## SUPPLEMENT TO THE

### MARK V SPARE PARTS LIST

The Mark V Spare Parts List (PL-685 - 4/79) shows all the parts for our current production model and, in general, can be used by all Mark V owners to determine part numbers. However, there have been several changes over the years and, if you note differences between our parts list and your model, please review this supplement carefully. Each change is listed along with an illustration showing the parts before the change.

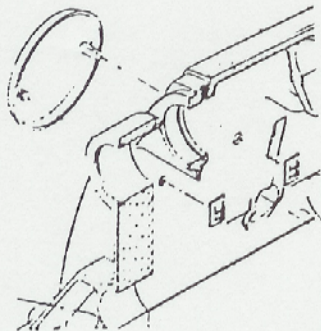
2. For a short time the 504190 (Ref. 70) eccentric bushing did not include the tapped hole. When purchasing the new bushing, the 139367 socket set screw should also be purchased.

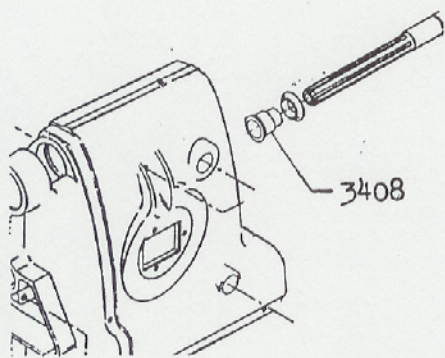
5. Also in 1955, the nut (2802) to retain the sheaves and spring was replaced by a retaining cap and snap ring. The (2895) sheave was replaced with one having a longer bearing/insert. If you have this model, the proper part numbers (above) must be ordered. If owners having this model require a replacement motor, it will be necessary to also purchase a snap ring (501645), a spring retaining washer (504553), a spring (509226) and a floating sheave (504208).

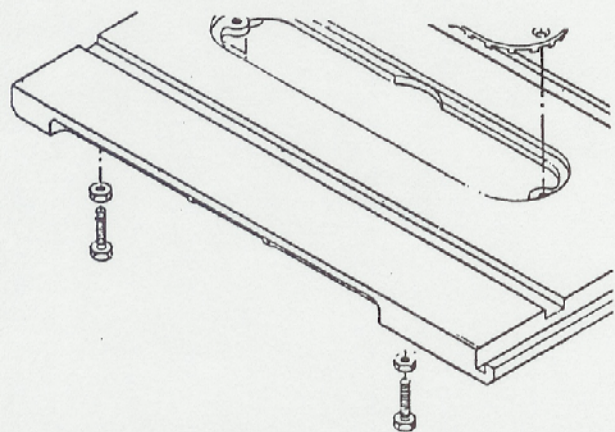
6. In late 1973, starting with Mark V serial #SS3191, the spring case (501657) was replaced with a heavy flat washer and a new, better spring was substituted. The method of holding them on the shaft (retaining ring 501645) is the same. Therefore, if either the old spring cap or the old style spring is ordered, both the new spring (509226) and washer (504553) will be substituted as a pair.

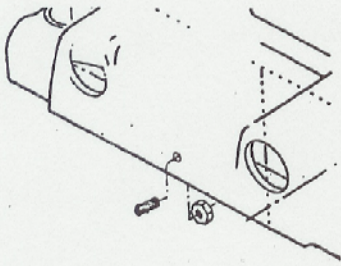
8. In 1960, several minor changes were made in the saw table. When replacing the old table, order assembly (504245) which includes the new table (504246) and front guide bar (501378). They replaced the regular cap screws with nylok cap screws (504252) which eliminates the need for the jam nuts illustrated here.

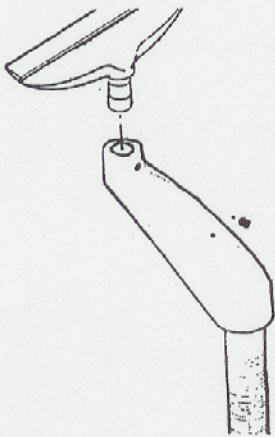
Starting with Mark V serial #SS1001, another small modification was made. The front underside of the table is being machined to provide positive setting of the guide bar. This requires the use of three spacing washers (504267). They are not required for models previous to #SS1001 having separate tables and guide bars.
